EL12-073b

**SB-10048359-2264****2009-2013 FX; FUEL GAUGE READS "EMPTY" AFTER FILLING TANK**

**APPLIED VEHICLES:** 2009 - 2013 FX35 and FX50 (S51)**APPLIED VINs and****DATES:** Vehicles built before: JN8CS1MW(\*)DM 173541 and December 19, 2012  
JN8CS1MU(\*)DM 141609 and December 19, 2012  
JN8BS1MW(\*)DM 100235 and December 19, 2012  
JN8BS1MW(\*)DM 100266 and February 8, 2013**IF YOU CONFIRM:**

Figure 1

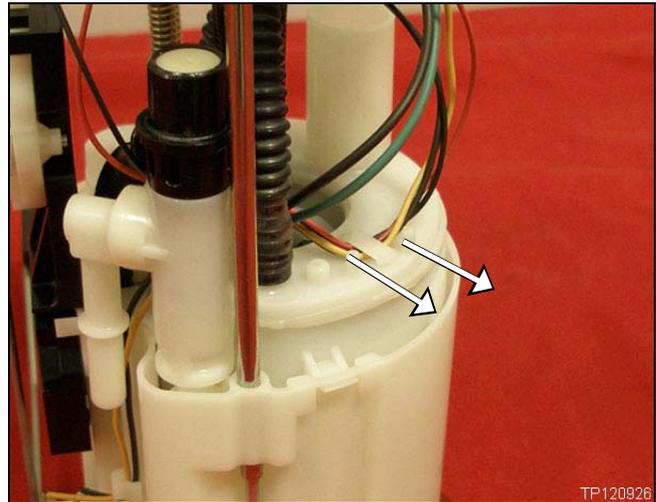
- a. Remove the wires from the retention feature (see Figure 1).

Figure 2

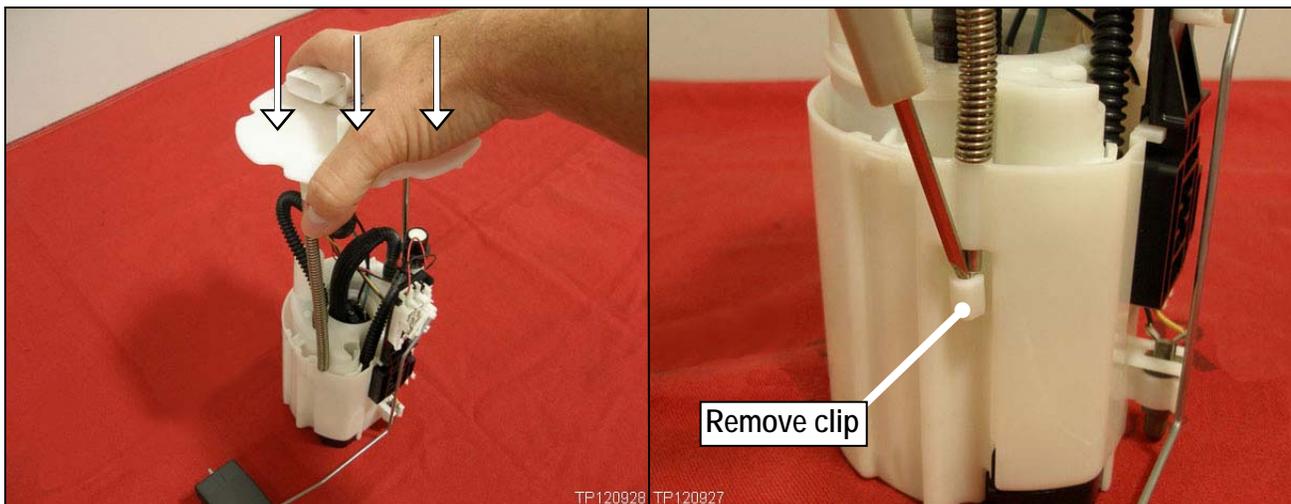
- b. Push down on the top of the fuel pump module, and then remove the clip from the spring loaded rod with a suitable tool (see Figure 2).

**NOTE:** There is only one clip.

Figure 3

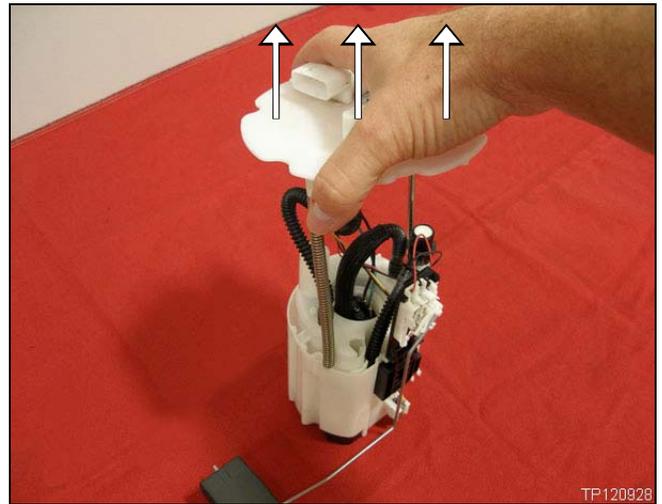
- c. Raise the top of the fuel pump module until the rods pull out completely (see Figure 3).

Figure 4

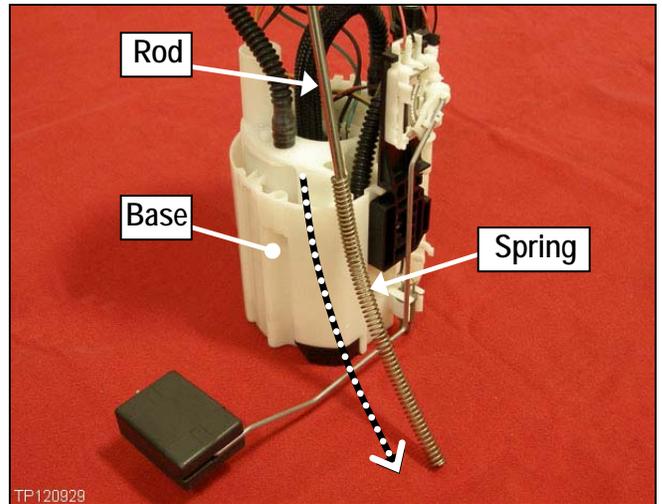
- d. Remove the spring (see Figure 4).
- Do NOT reuse this spring. Discard it.

Figure 5: Fully assembled, viewed from backside.

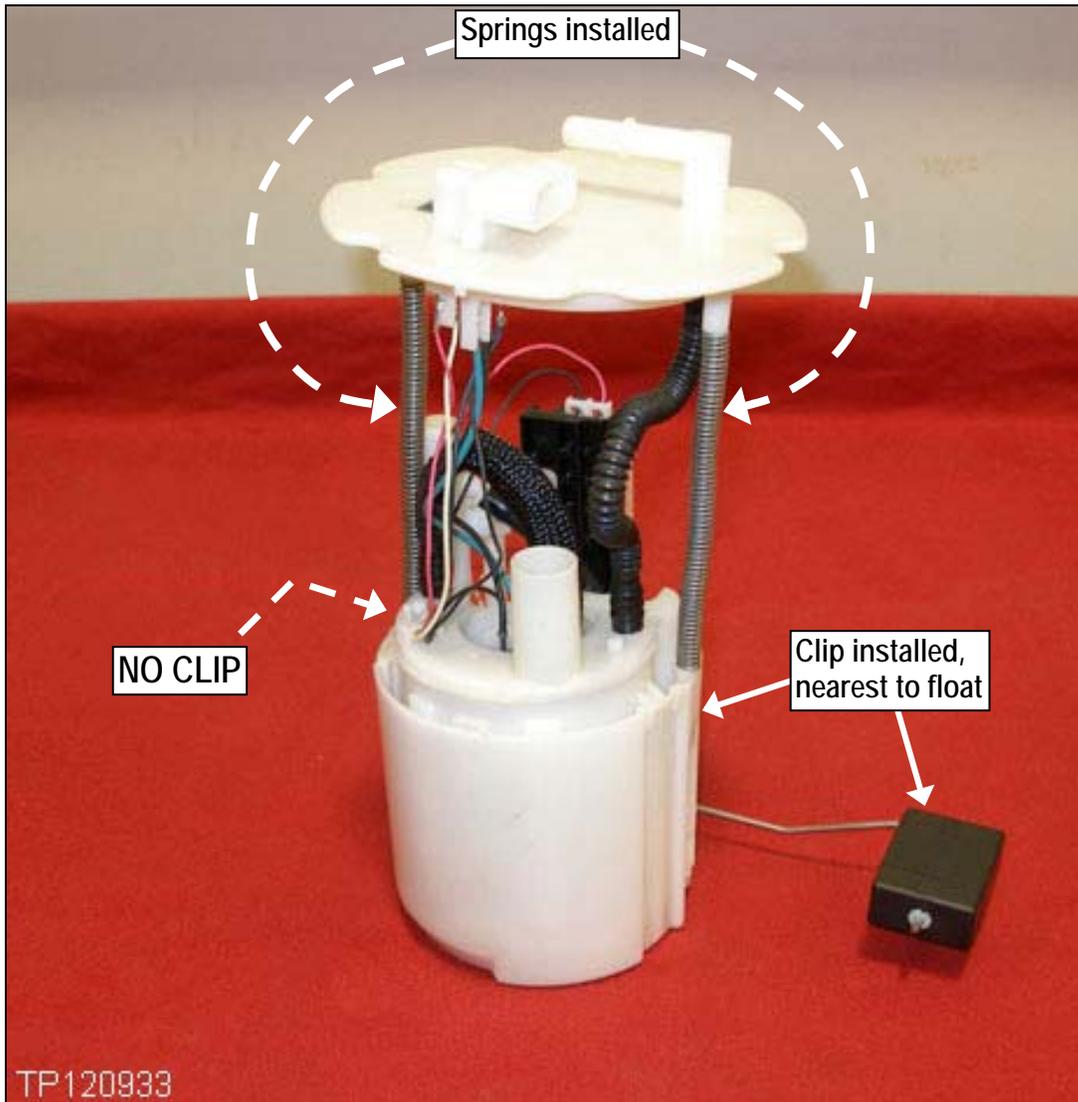
3. Install two (2) new springs (see **PARTS INFORMATION**), one on each rod.  
**NOTE:** New springs are identified with green coloring.
4. With the new springs installed, insert the rods into the holes of the fuel pump module base.
5. Reinstall the clip at its original location, nearest to the float (see next page, Figure 5).
  - Replace the clip if broken or damaged with the one listed in **PARTS INFORMATION**.
  - To access where the clip mounts to the rod, push down on the top of the fuel pump module.
  - Make sure the top of the fuel pump module does not bind when moved up and down.
6. Reposition the wires under the retention feature.
  - The "green" and "black" wires do NOT go under the retention feature.
7. Install the fuel pump module in the fuel tank.
  - Refer to the **B ENGINE> FL Fuel System** section of the ESM, if needed.
8. Verify the fuel gauge reads correctly.
